Groundwater Application Review Summary Form

Application # G- 19013

PUBLIC INTEREST REVIEW FOR GROUNDWATER APPLICATIONS

TO: Water Rights Section Date 10/29/2020
 FROM: Groundwater Section Jen Woody
 Reviewer's Name
 SUBJECT: Application G- 19013 Supersedes review of 9/17/2020
 Date of Review(s)

Figure 3. Water-Level Measurements in Nearby Wells

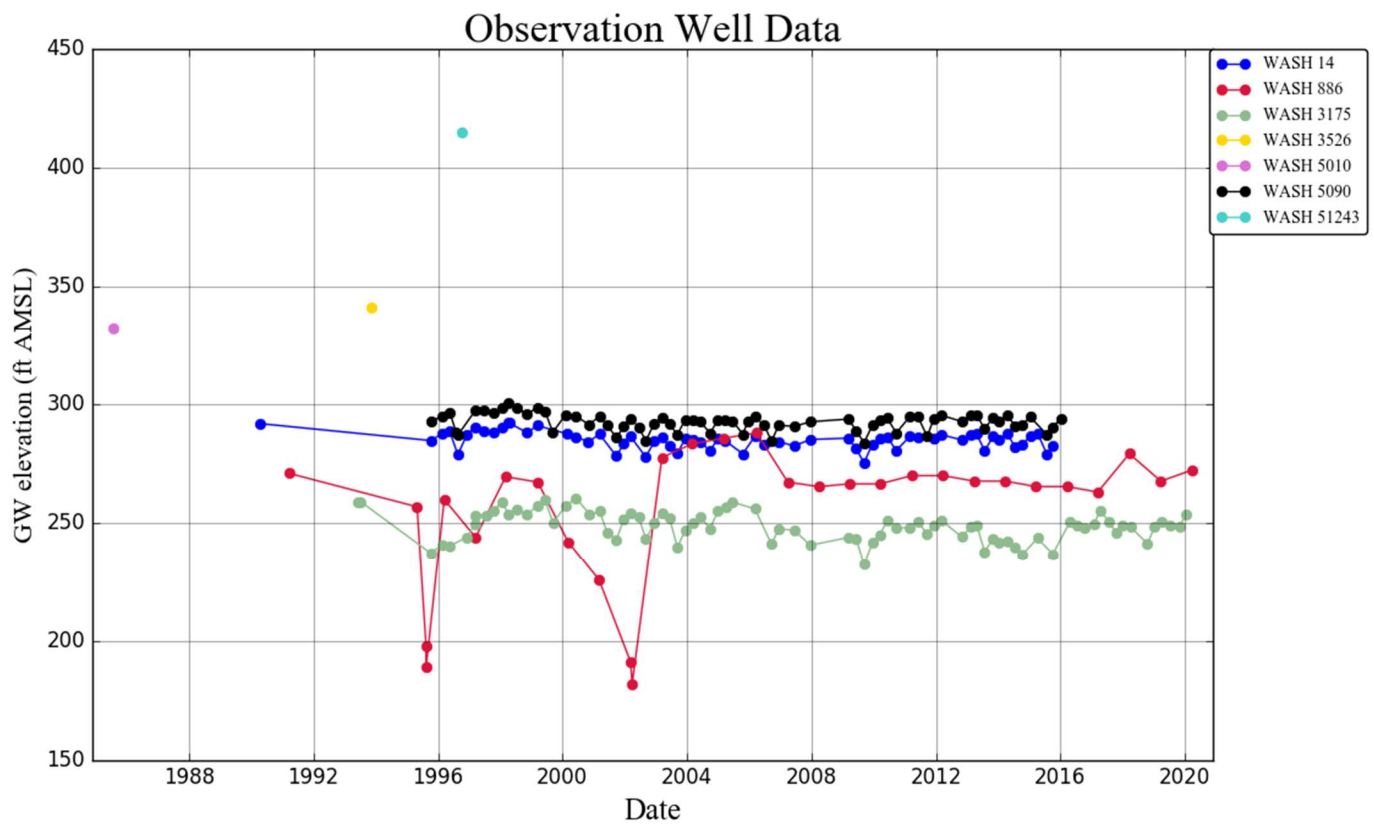
The proposed pumping rate of 9 gallons per minute (gpm) is unlikely to create drawdown interference with nearby wells that prevents access to water. Most neighboring tax lots are larger than 20 acres, indicating development by exempt wells is sparse. Nearby wells access a variety of water bearing zones within the CRBG aquifer system and show reasonably stable trends (see Figure 3). Water use and water level monitoring conditions are recommended to protect existing users. _____
